# PPI MCB-HCB Detail Specifications and Connector Pinout

IEEE P802.3ba

Jan 13 2009

Ali Ghiasi  
Broadcom Corporation  
aghiasi@broadcom.com

# 40GBase-SR4 Optical Lane Assignment

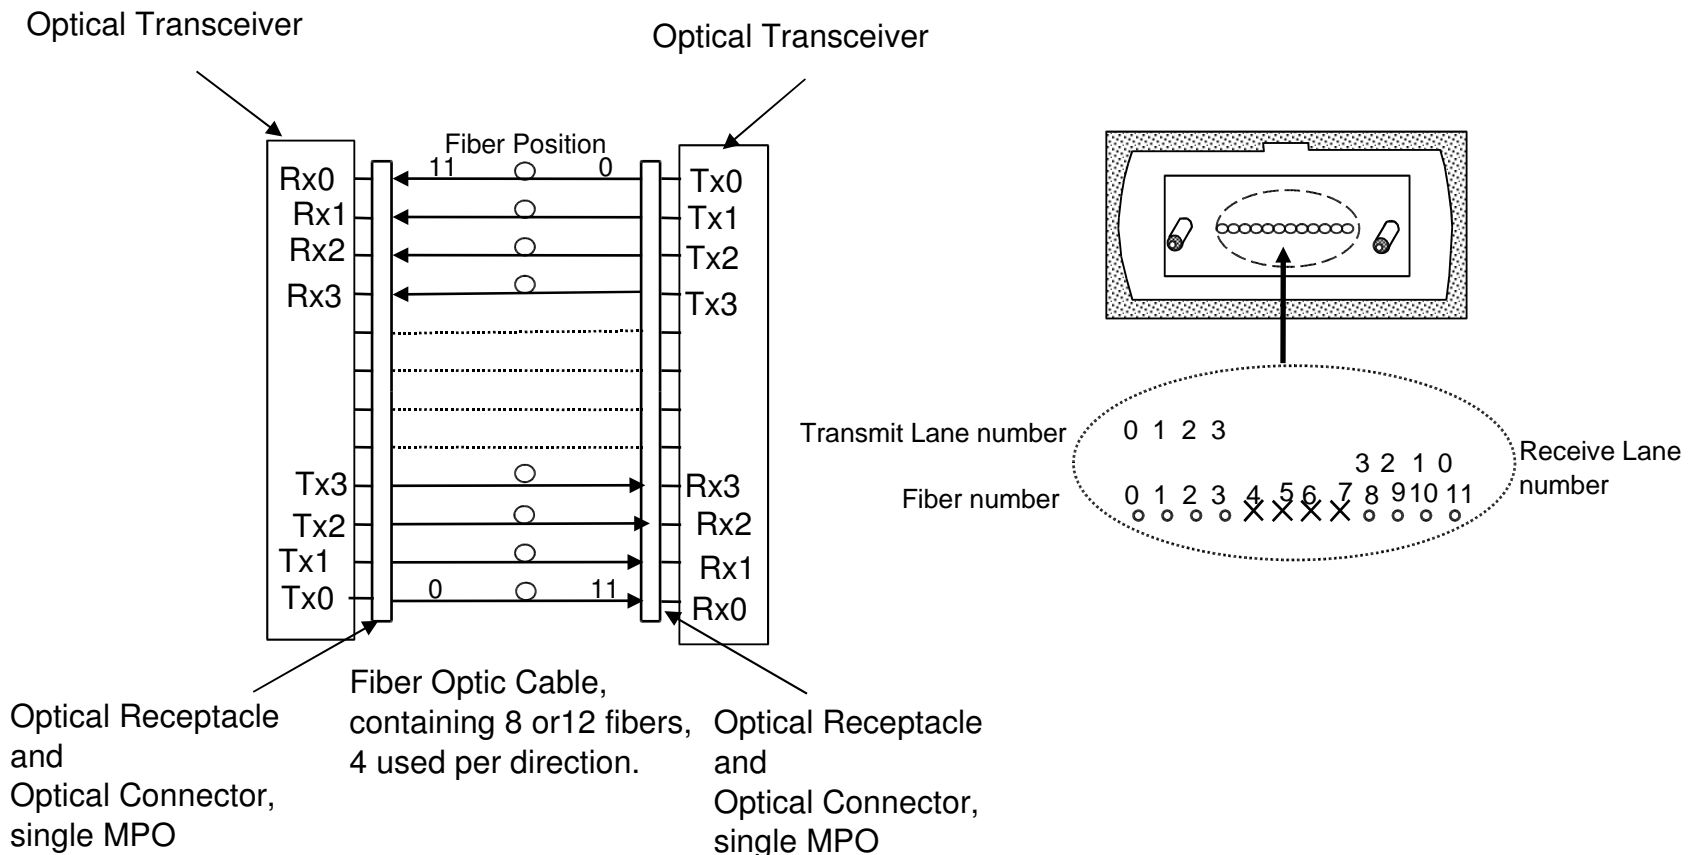
- Figure 86-2 need to be updated to show fibre position as shown below and in addition a connector diagram with TX/RX lanes as well as fibre position is required.

# 40GBase-SR10 Optical Lane Assignment

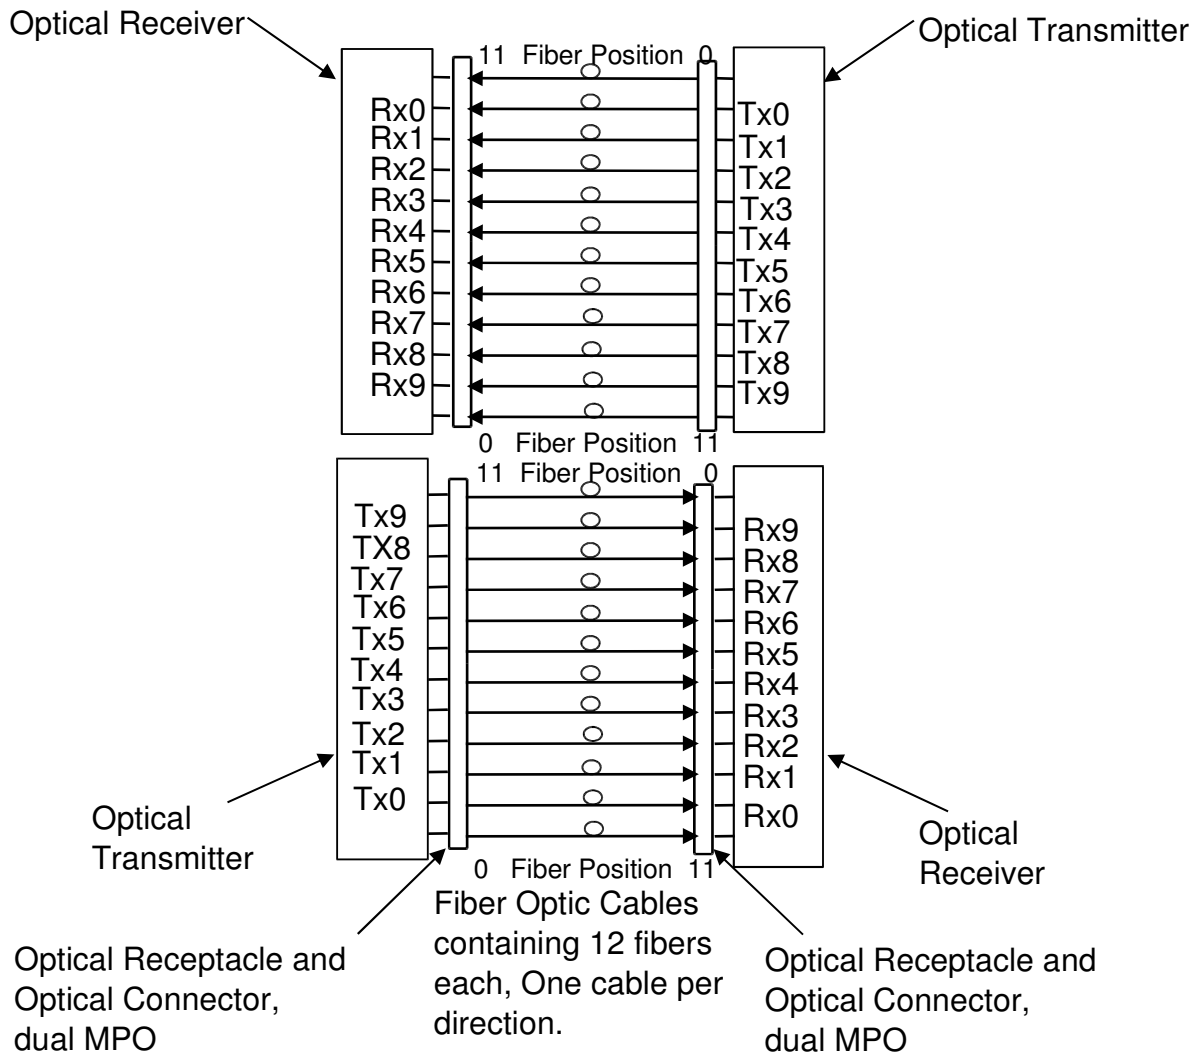
- Figure 86-2 need to be updated to show fibre position as shown below for SR10.

# Connector Lane Assignment

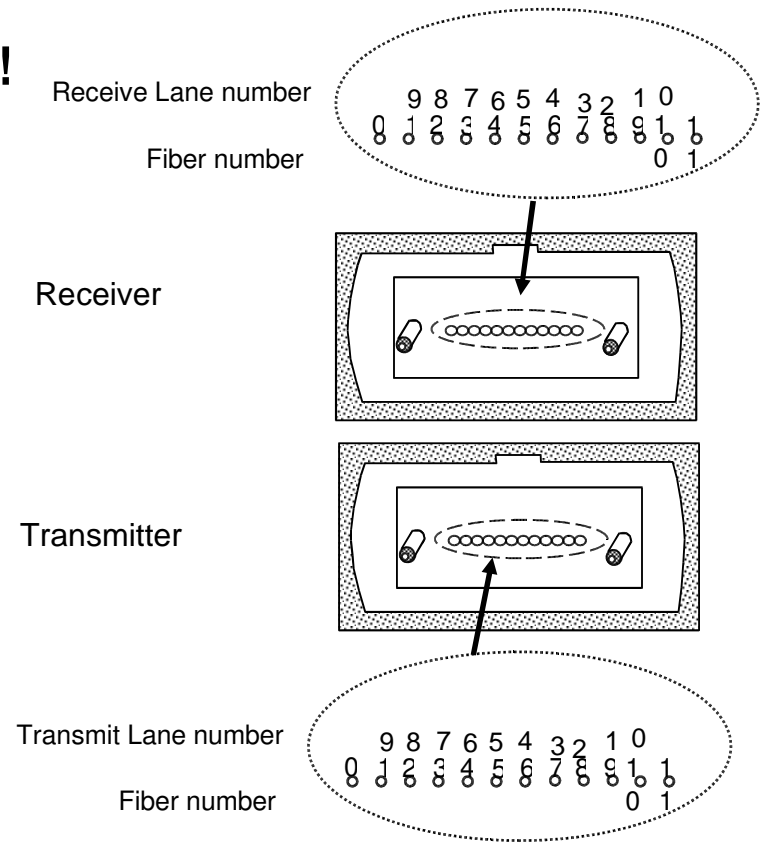
- Assumes Table 85-9 pin assignment and without crossover in cable.
  - Not consistent with the SR4 definition!
  - We may want to consider reorder the table pin out 85-9 or just let MLD take care of the rotation.
